SUPPLEMENTAL NOTICE NO. 3
INVITATION TO BID NO. RSP1-RX-02
SUPPLY OF 15 MVAr 115 kV SHUNT REACTOR
TRANSMISSION SYSTEM EXPANSION AND
RENOVATION PROJECT PHASE 1 : SUBSTATION

SUPPLEMENTAL NOTICE NO. 3
INVITATION TO BID NO. RSP1-RX-02
SUPPLY OF 15 MVAR 115 kV SHUNT REACTOR
TRANSMISSION SYSTEM EXPANSION
AND RENOVATION PROJECT PHASE 1 : SUBSTATION

**Shunt Reactor
Specification No. 383**

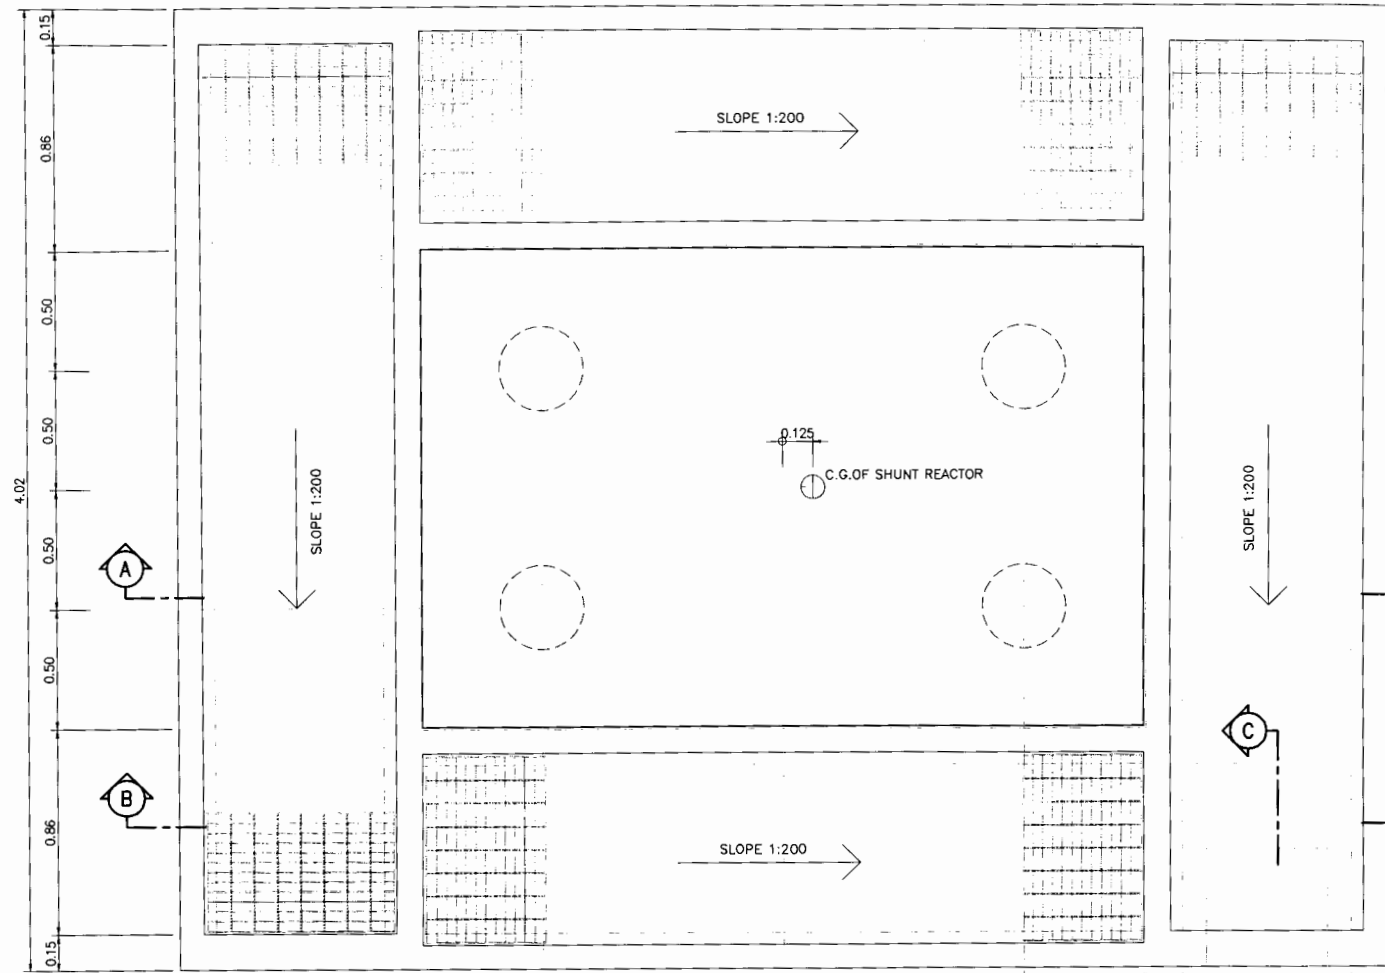
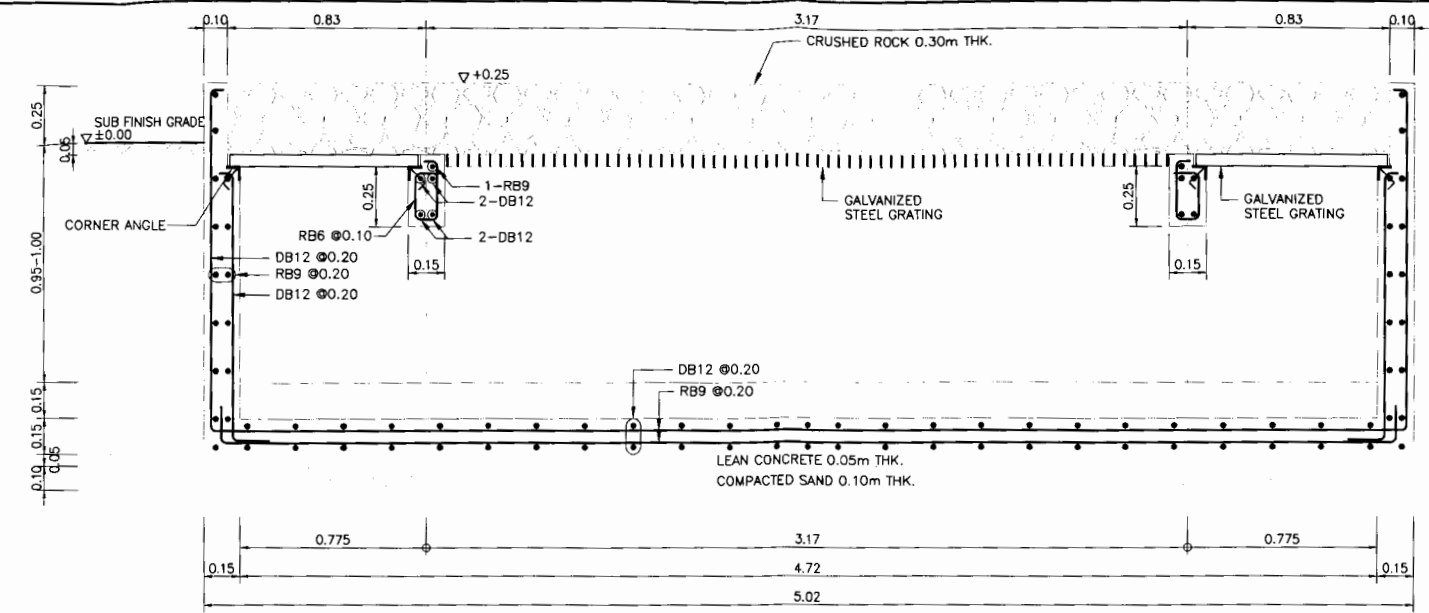
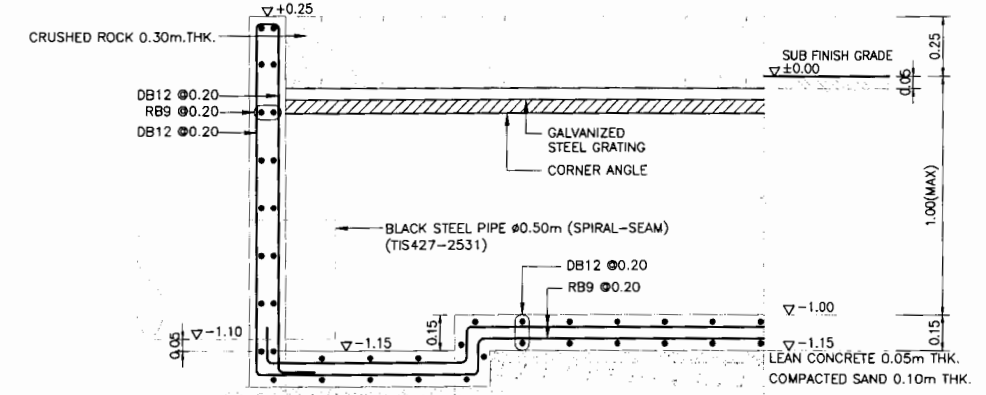
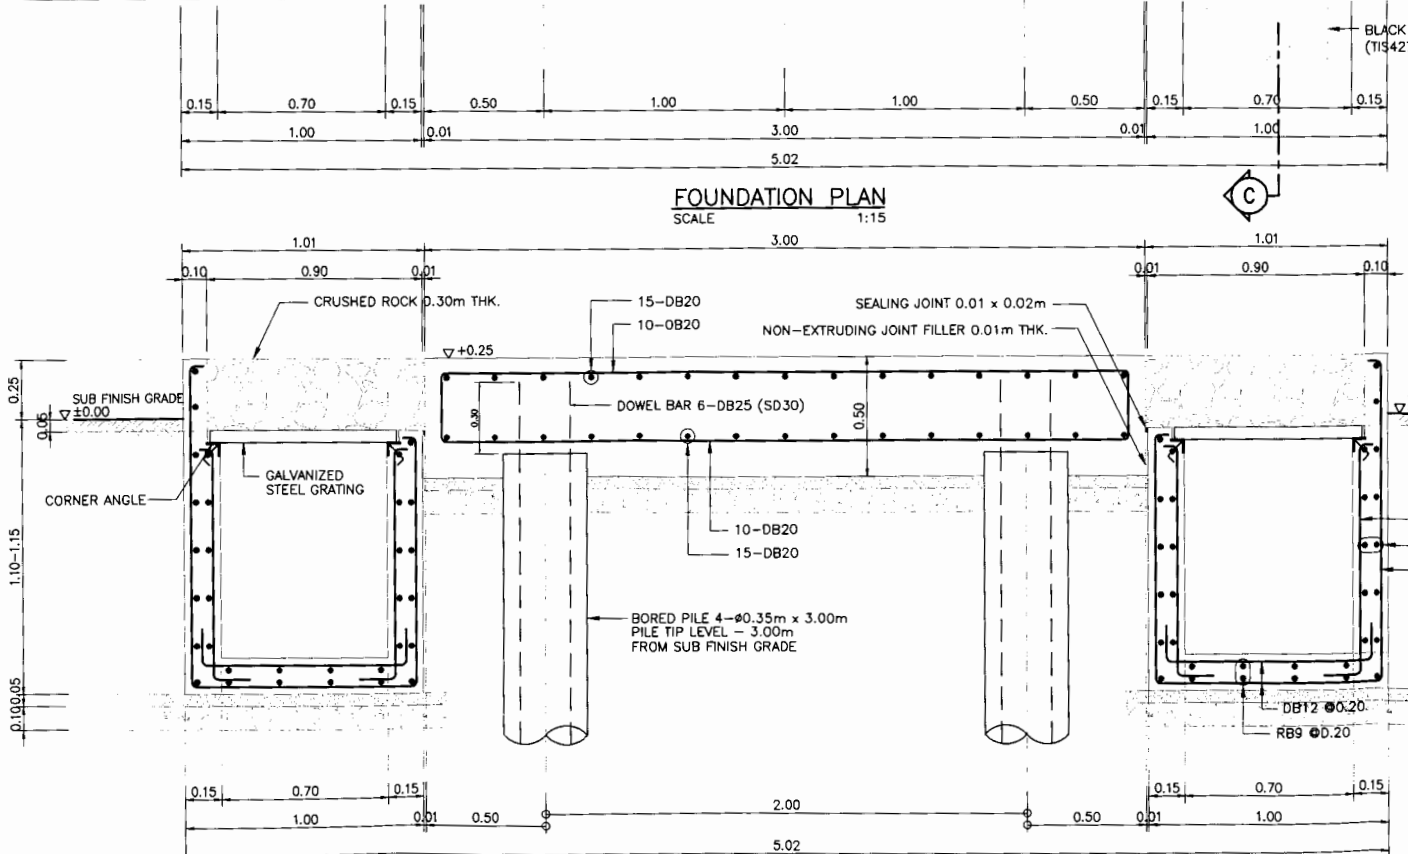
- Add the attached Drawing No. TT/SRT-FD-SR-7-01 Sheet 01/01 Rev.2 to this section.

4. The shunt reactor shall be installed at foundation according to drawing TT/SRT-FD-SR-7-01 without exceed oil pit.
